**Summary of November 2015 and December 2015 Discussions of Draft Limitations and Conditions
and Supplemental Information for the FULL SPECTRUM LOCA (FSLOCA) Evaluation Model
(Non-Proprietary)**

December 2015

Westinghouse Electric Company LLC
1000 Westinghouse Drive
Cranberry Township, PA 16066

Figure 3-3: Figure 17 from AEP-NRC-2009-23, D. C. Cook Unit 2 ASTRUM Analysis Containment Pressure Comparison

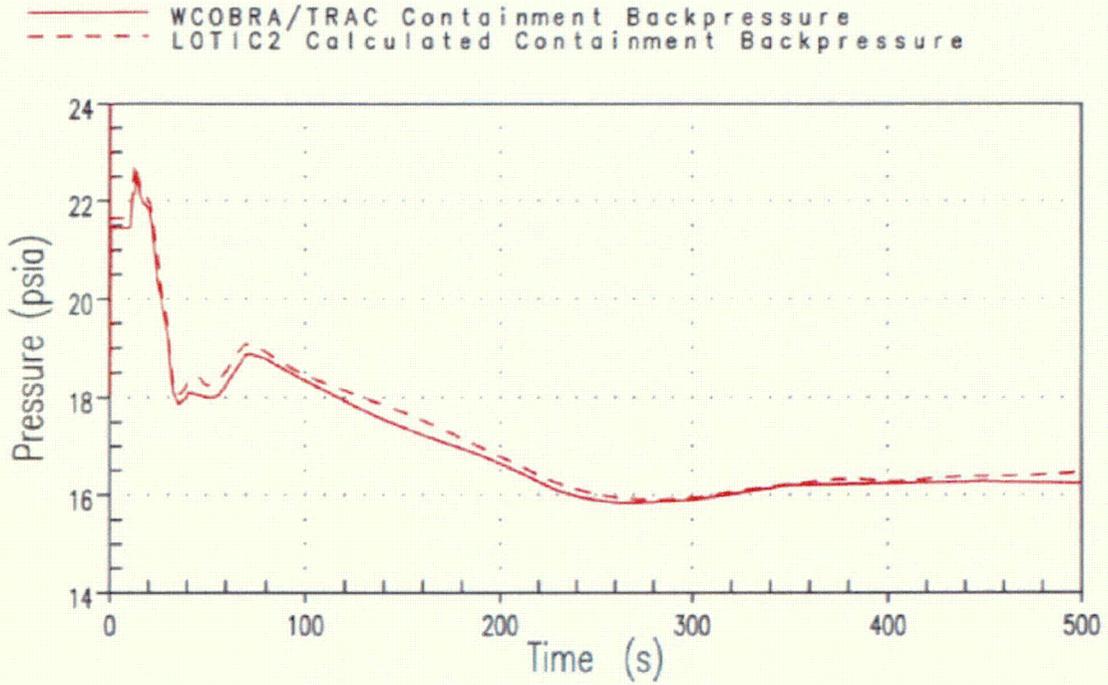
As previously mentioned, the D. C. Cook Unit 2 WCOBRA/TRAC reference transient input containment pressure and the associated LOTIC2-calculated containment pressure are shown in the figure on page 26 of Enclosure 2 to AEP-NRC-2009-23 for the ASTRUM analysis. This figure has been included herein as Figure 3-3.
